Memorandum to the City of Markham Committee of Adjustment

File: A/125/20
Address: 11175 Kennedy Rd – Markham, ON
Applicant: Buddha Meditation Center
Agent: N/A
Hearing Date: January 20, 2020

The following comments are provided on behalf of the West Team. The property is split zoned “Agricultural One (A1) Zone” and “Rural Residential One (RR1) Zone”. The applicant is requesting relief from the following requirement under By-law 304-87, as amended, to permit:

SITE PLAN

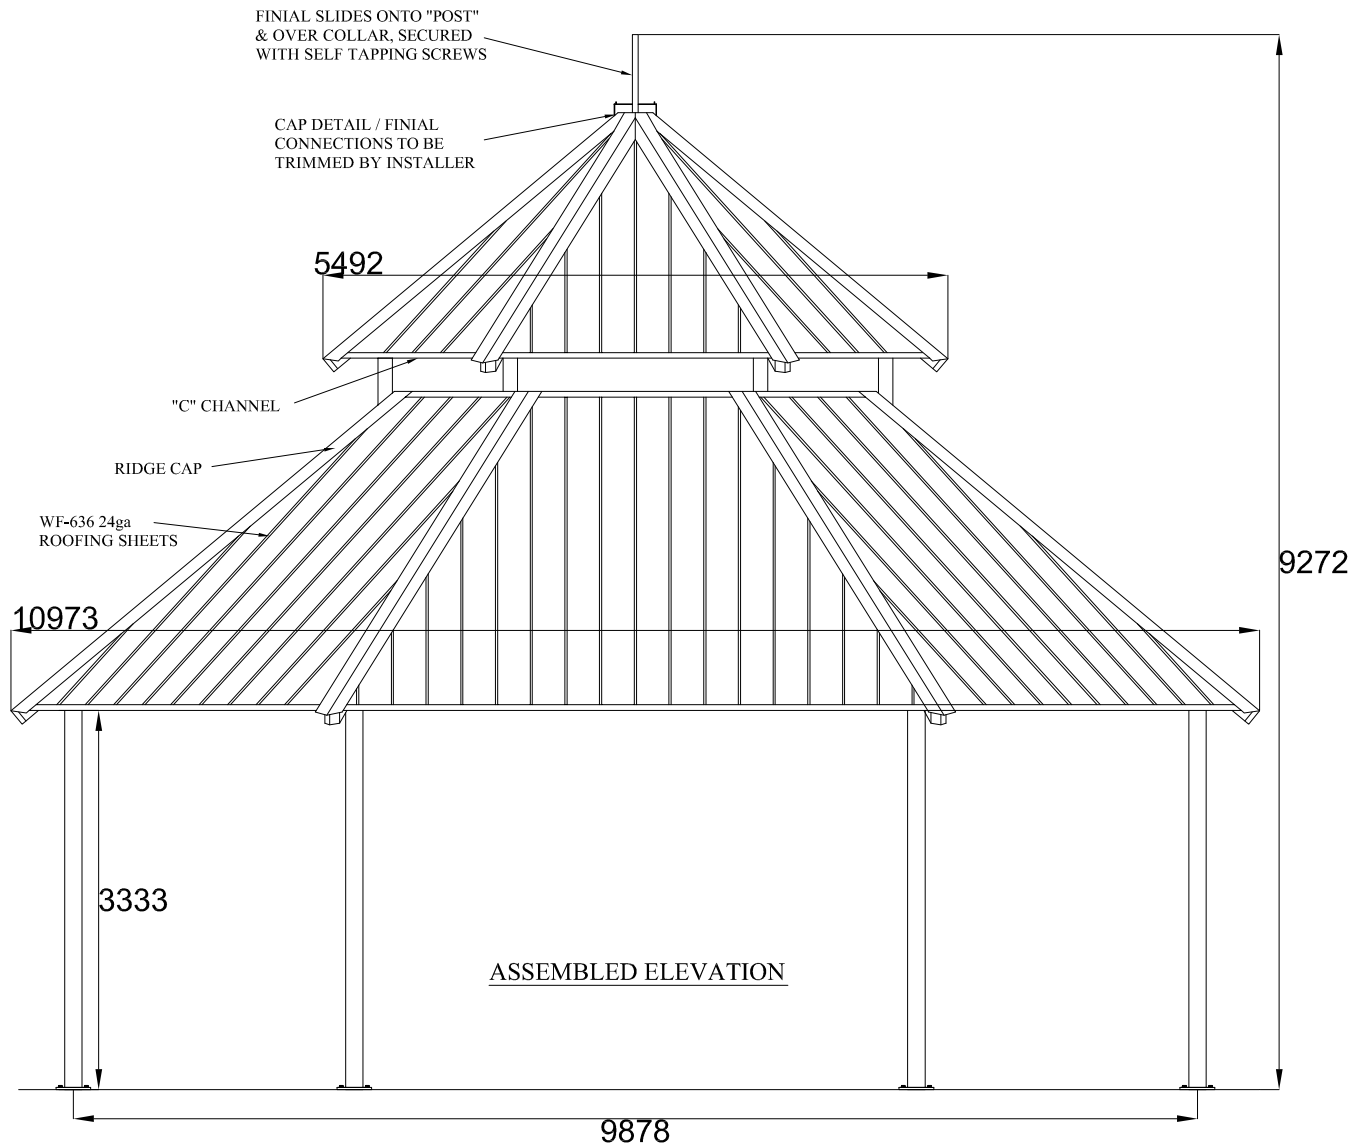
The applicant is requesting an accessory structure to be located a minimum distance of 33.0 m (108.27 ft) from the centre line of Kennedy Road to the front of the proposed development, whereas the By-law requires a minimum setback of 40.0 m (131.23 ft) from the centre line of Kennedy Road to any part of a building or structure. This is a reduction of approximately 7.0 m (22.97 ft).

The intent of the provision is to provide for adequate space for any future right-of-way widening’s. Kennedy Road is a Regional arterial road that is owned and operated by the Regional Municipality of York. Map 12 – Street Network in York Region’s Official Plan 2010 indicates a planned street width of up to 36.0 m (118.11 ft). The Regional Municipality of York provides no comments in relation to the proposed development (Appendix “C”). Staff’s primary concern is related to any future need to expand the existing Kennedy Road

right-of-way. With consideration to the received comments, staff are satisfied that the approval of this variance would not adversely inhibit any future Kennedy Road right-of-way widening's, and do not object to the variance.
